Our Ref: PL/25/1705
Your Ref:

23rd December 2025

RE: PROPOSED WORKS TO 1NO. SYCAMORE TREE, 1NO. MAPLE TREE AND 1NO. HORSE CHESTNUT TREE AT 18 PICTON WAY, CAVERSHAM, READING - G1 OF TREE PRESERVATION ORDER NUMBER 40/03.

Figure 5 - TPO extract of tree species and location in G1

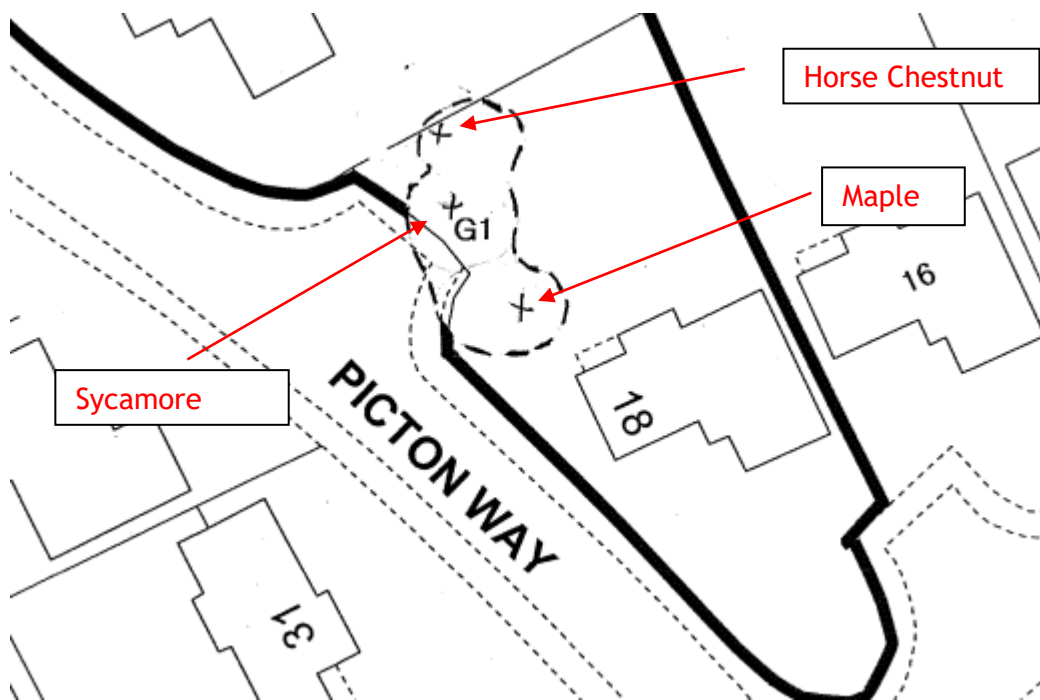
The Sycamore in your application is actually a Maple, however as discussed with Mr Hammond, works to the Sycamore (adjacent to the Maple) were also identified and are discussed within this letter. For absolute clarity, I have annotated an extract from the TPO plan which indicates the species of each tree and its position in Figure 5 below.
